THE SUMMIT SUBDIVISION

APPLICATION NUMBER 19 DATE May 4, 2006
APPLICANT The Summit Subdivision
REQUEST Subdivision

DETAIL SITE PLAN

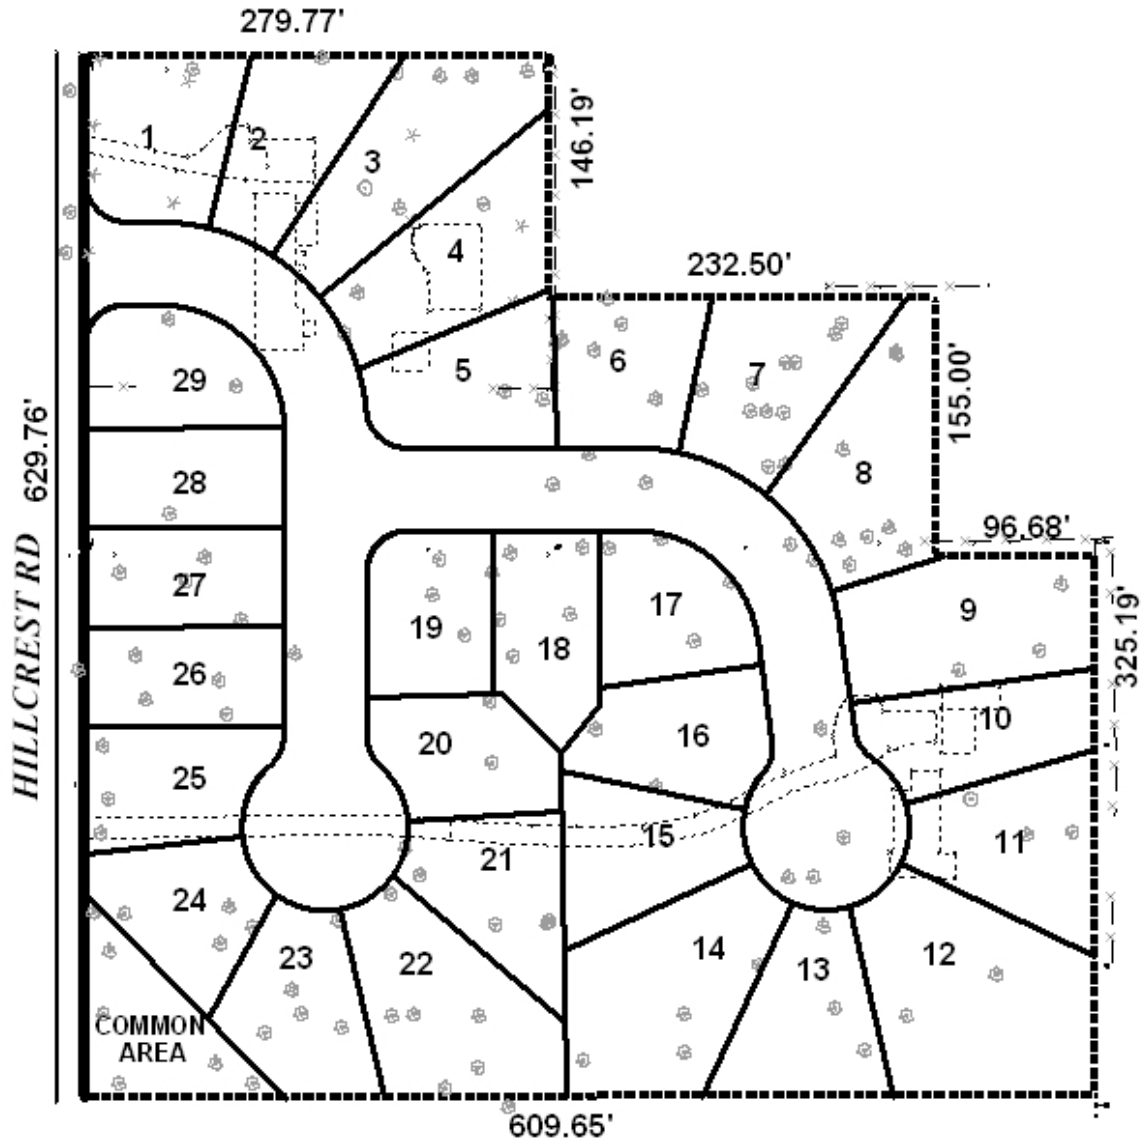
The site involves the creation of new streets, which must be constructed and dedicated to City Engineering standards. Because the site adjoins a one-acre landlocked parcel to the Southeast, a street stub should be provided and a temporary turnaround constructed to City Engineering standards until such time as the road is continued. For access management, lots 1 and 24-29 should be denied direct access to Hillcrest Road.

The plat shows a common area at the Southwest corner that has access only to Hillcrest Road. As a means of access management for Hillcrest Road, the common area should be reconfigured to have access to the new street. If this is a detention area, it should be so labeled, and a note should be placed on the final plat stating that maintenance of the common (and/or detention) area is the property owners' responsibility.

It seems that some lots will not satisfy the minimum lot size of 7200 square feet, although the site overall averages approximately 11,000 square feet per lot. Therefore, the final plat must show all lots meeting the 7200 square-foot minimum prior to being signed.

Based on the preceding, this application is recommended for Tentative Approval, subject to the following conditions: 1) that the final plat show all lots meeting the minimum lot size of 7200

square feet; 2) compliance with Urban Forestry comments (Property to be developed in compliance with state and local laws that pertain to tree preservation and protection on both city and private properties (State Act 61-929 and City Code Chapters 57 and 64). Preservation status is to be given to the 72" Live Oak Tree located on the North side of Lot 29, the 72" Live Oak Tree located on the South side of Lot 28, the 60" Live Oak Tree located on the West side of Lot 20, the 56" Live Oak Tree located on the West side of Lot 16, and the 76" Live Oak Tree located on the West side of Lot 9. Any work on or under these trees is to be permitted and coordinated with Urban Forestry; removal to be permitted only in the case of disease or impending danger.); 3) construction and dedication of the new streets to City Engineering standards; 4) the provision of a street stub and temporary turnaround (built to City Engineering standards) to the landlocked parcel to the Southeast; 5) the placement of a note on the final plat stating that lots 1 and 24-29 are limited to a single curb cut each (subject to Traffic Engineering approval) and is denied direct access to Hillcrest Road; 6) the reconfiguration of the common area to have access to the new street instead of Hillcrest Road; and 7) the placement of a note on the final plat stating that maintenance of the common area is property owners' responsibility.
